INDESIT company

Model type:
BO3034V

Commercial code:
F027408

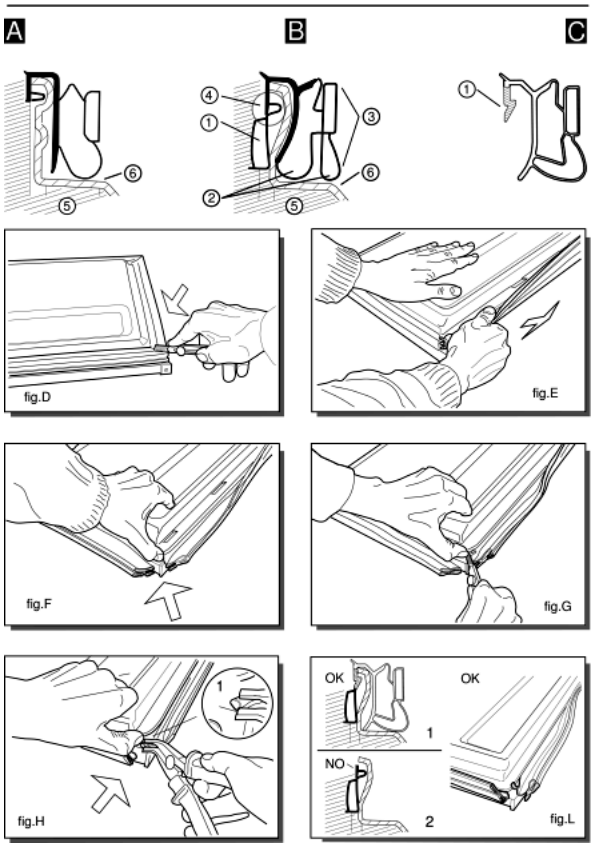
0521123: SEALS FOR DOORS FOAMED AS ONE PIECE

Various types of gaskets with different profile, as shown in figures (A) and (B), are used to fix the door (fig. A-5; B-5) and the inner door (fig. A-6; B-6) on the block foamed doors of combined freezers and refrigerators.
---Ilpea profile 245; 179; 412 (fig.A)
---Ilpea profile 287 (fig.B)
When replacing gaskets with profiles 245; 179; 412 these are fixed with screws (2 per corner) to the door.
Gaskets with profile 287 can not be used as spare parts but are designed to house the Ilpea type 900 gaskets (see figure C).
When replacing the gasket (287), once it is removed you will find a pocket (fig. B-1) between the door and inner door.
The rigid tooth (fig.C-1) of the gasket (900) is inserted inside between the pocket and the inner door, doing away with the need for screws.
Gasket with profile 287 is easy to identify since it has an exterior double edge (fig.B-2) which acts as a cushion when the door is closed.

To replace this gasket, follow these steps:
---Dismount the door and cut the four corners of the gasket along the joint (fig.D);
---lift the gasket and pull it carefully along its full length without tearing it (fig.E).
The purpose here is to detach the inner door slightly from the foam along the exterior edge for a depth equal to that of the gasket (fig.B-3);
---lift the corner of the inner door slightly, prising it up with your thumb (fig.F). Do not use a tool which might break the inner door;
---continue cutting the gasket inside the inner door for about 6 mm (fig.G);
---push in the tip of the pliers (type USAG N131) and pull outwards until you see the top edge of the pocket (fig. B-4) which is empty (fig.H-1);
---if you carry out this operation correctly (fig.L) you will be able to pull off the top edge of the pocket for the full length of the door.
If the gasket tears before the top edge (fig. L-2) you should repeat this operation from the other corner of the door.

N130084FIG1

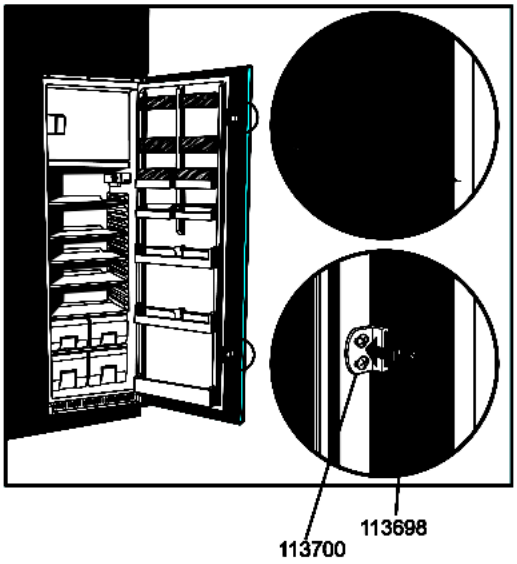
n1030084: New sliding blocks for fixing the furniture door to the refrigerator door

Since October 2004, the Carinaro factory has been using new sliding blocks for fixing the furniture door to the refrigerator door.
The new items are fixed to the side of the refrigerator door, whereas the previous ones were fixed to the front.
The doors are no longer provided with sixteen 2.6 mm holes on the front for fixing the old slides.
The new sliding blocks can also be fitted on premodification models. Proceed as shown in the attached figure (N1030084fig.1).
When replacing the sliding blocks on premodification models it will necessary to replace both guides.
This modification has involved changing the installation KITS

NB - Door spare part codes have not been changed.

New parts

113698 - LARGE NYLON HOLDER SLIDE
113700 - NYLON HOLDER SLIDING GUIDE
